APPENDIX I
DRILLING MUD EFFECTS ON HYDROGEOLOGIC TESTING

BWIP DSCA/APP I/LOGSDON

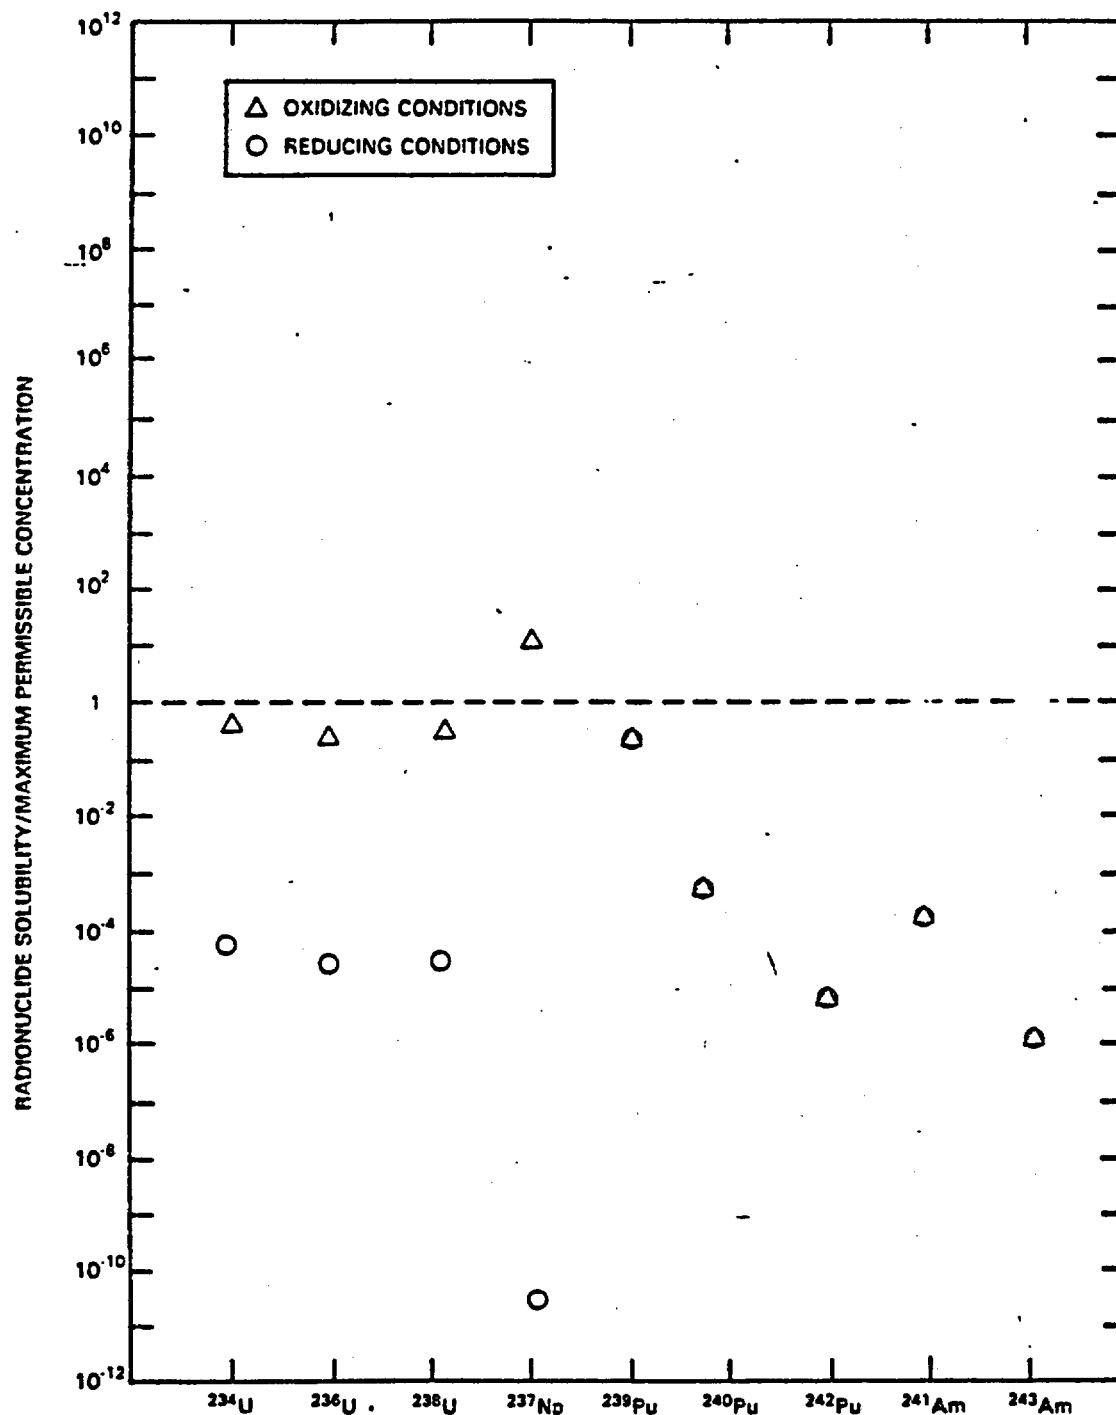
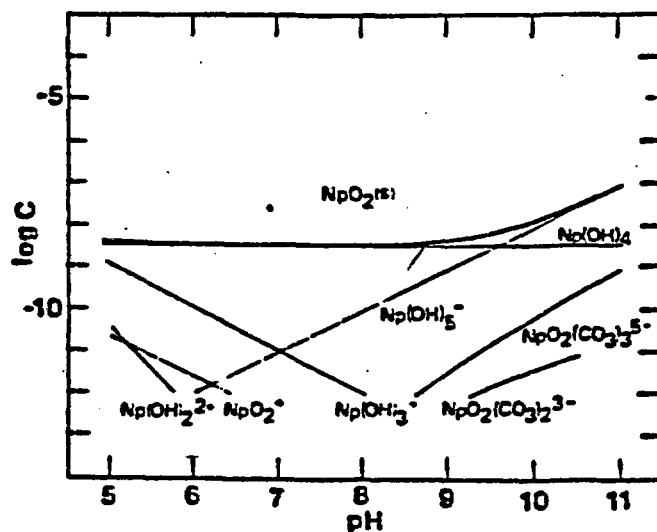
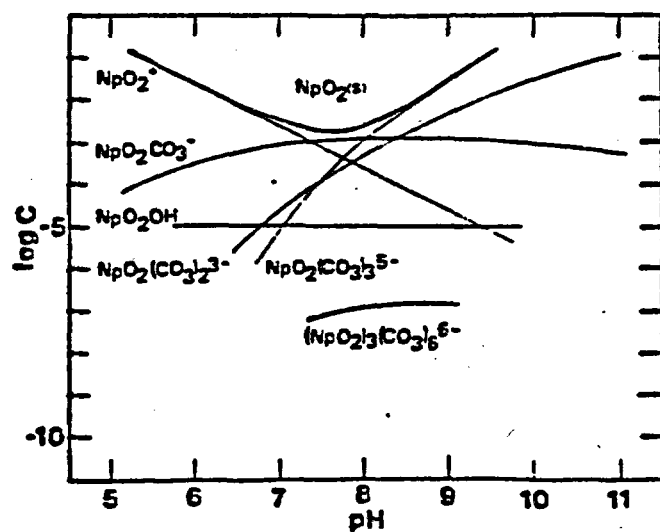
Comparison of the solubility to MPC ratios presented in the BWIP SCR with Allard solubilities to MPC (adjusted from ICRP 30) indicate large apparent discrepancies. These discrepancies were identified for all the nuclides of Am, Pu, Np, and U reported in the BWIP SCR for both oxidizing and reducing conditions (Table 6 and Figure 1). Most of the ratios differed by 5 or more orders of magnitude, a level of disagreement which would introduce an unacceptable level of uncertainty and risk into contaminant release scenarios.
